Work Order ID 135171

Item Name: QR Heli-Utility-Basket™, Short, HD Lid, Spacepod™ & Squirrel Cheek Comp., LH/RH

DART SERVICE INSTRUCTION

TO AMEND INSTALLATION INSTRUCTIONS D350-607-3 Rev.D,
INSTALLATION INSTRUCTIONS D350-607-4 Rev. C AND
INSTRUCTIONS FOR CONTINUED AIRWORTHINESS ICA-D350-607 REV. 6
REF TCCA STC: SH94-14
REF FAA STC: SR00213NY
REF EASA STC: EASA.10016996
REF BRAZILIAN STC: 2007S03-03/-04/-05/-06

FIGURE 1: INSTALLATION OF D4775-041 FWD STRUT

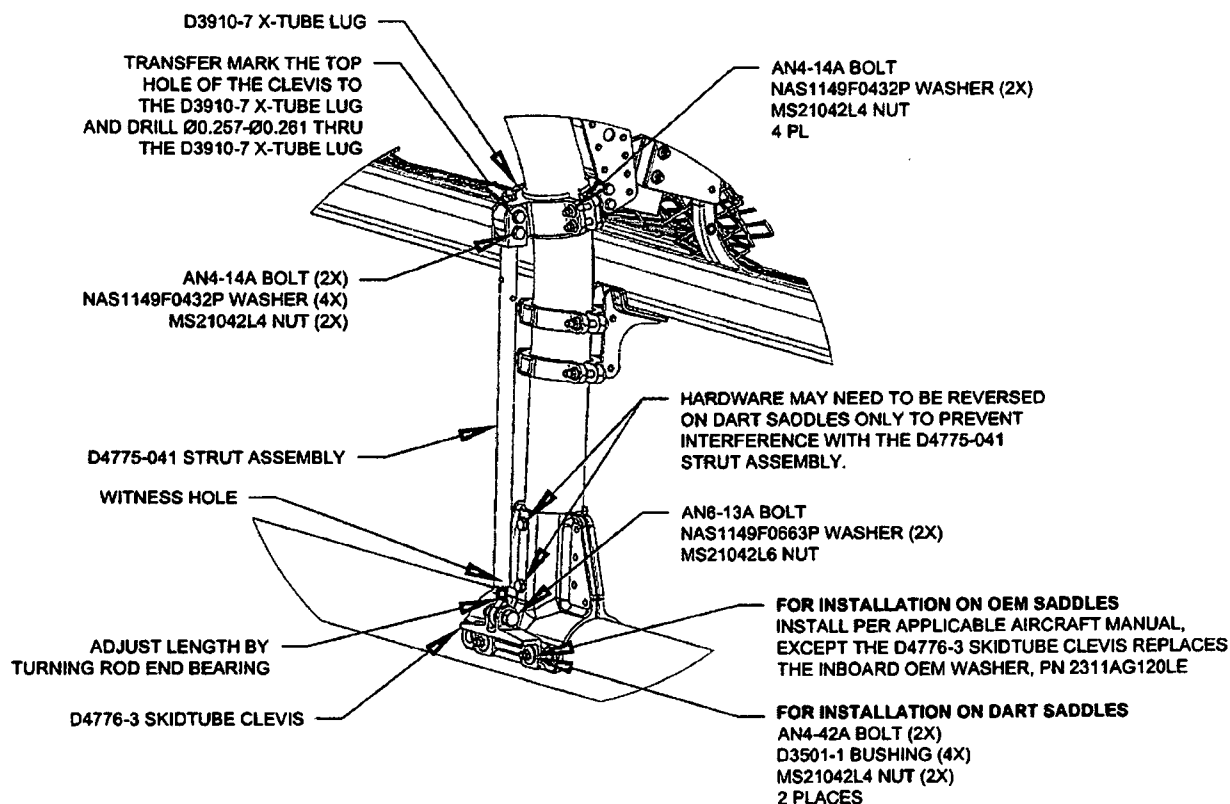
Modify the quantities for D3910-5 and add D3910-7 as follows:

- 3.1 Substitute the Forward Lower D3910-5 X-Tube Lug with the D3910-7 X-Tube Lug as shown in Figure 1.
- 3.2 Install the forward D4775-041 Strut Assembly. Transfer mark from the upper hole on the clevis of the D4775-041 Strut Assembly to the D3910-7 X-tube Lug and drill thru the lug $\varnothing 0.257$ - $\varnothing 0.261$ as shown in Figure 1. Touch up chemical conversion coating per MIL-DTL-5541. Check the witness holes located at the bottom end of the D4775-041 Strut Assemblies to ensure that the thread from the rod end extends past the witness hole.
Torque MS21042L4/-4 nuts to 50-70 in-lbs (5.7-7.9 N-m). Torque MS21042L6/-6 nuts to 160-190 in-lbs (18.1-21.5 N-m).
- 3.3 Complete the installation in accordance with Installation Instructions D350-607-3 Rev. D or D350-607-4 Rev. C.
